THM 440-T4 / 4T60-E COMPLETE HYDRAULIC CHANGE FOR 93-94

CHANGE: A new design converter clutch regulator valve line-up, and a new design for the accumulator

93-04 Page 1 of 6

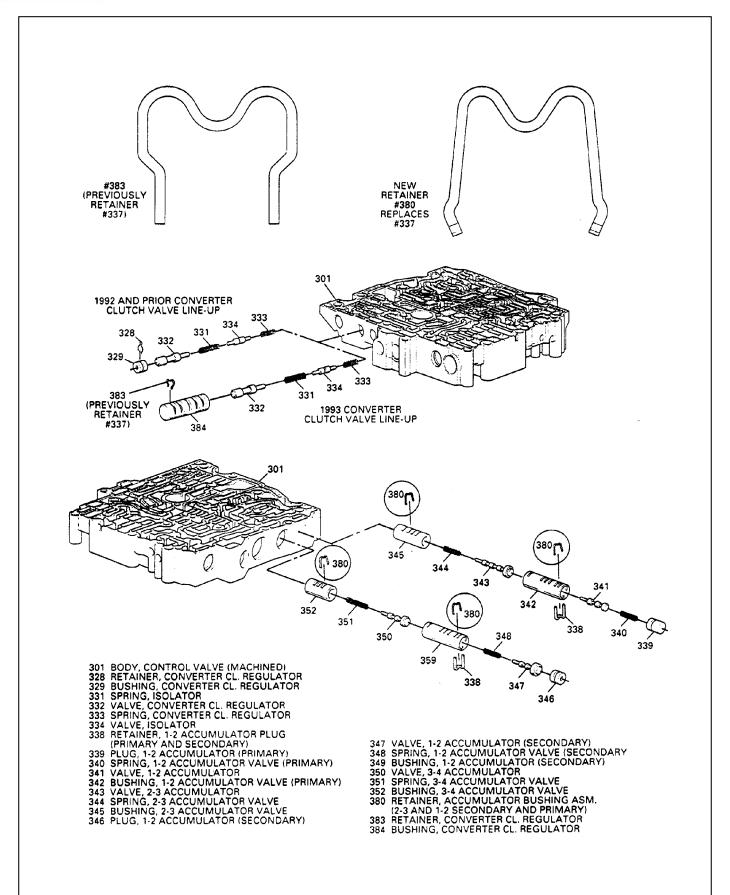
- (1) VALVE BODY CASTING The aluminum plug and retainer clip for the converter clutch regulator valve were eliminated and replaced with a new bushing. and a new style retainer. This makes it much easier to remove this line-up out of its valve body bore (See Figure 1). The 1-2 accumulator valve bushing (Both Primary and Secondary). the 2-3 accumulator valve bushing, and the 3-4 accumulator valve bushing were also re-designed for improved shift feel. These changes required changes in the worm tracks in the valve body casting, and the easiest way to identify the 1993 valve body is the diameter of the TCC regulator valve bore as shown in Figure 2.

Figure 3
AUTOMATIC TRANSMISSION SERVICE GROUP

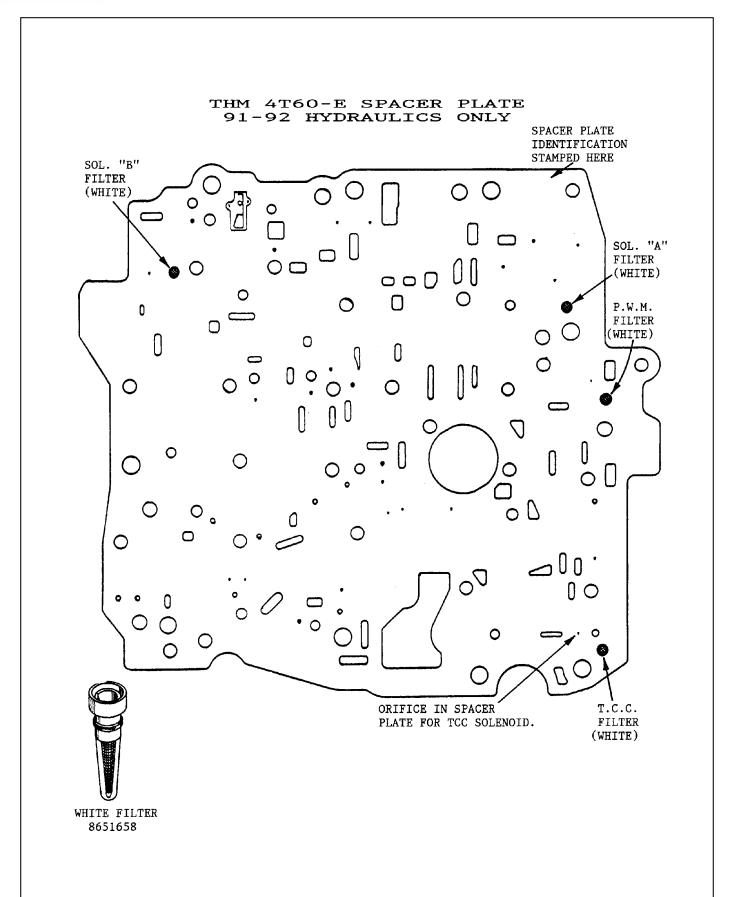
- (2) VALVE BODY SPACER PLATE Different hole spacing to accommodate the valve body and channel plate casting changes. Also the 91-92 hydraulics spacer plate has the TCC solenoid orifice in the spacer plate, and the 1993 hydraulics requires the screen and orifice assembly, with the "0" ring, that we seen in the THM 440-T4 transaxle (See Figures 3 and 4).
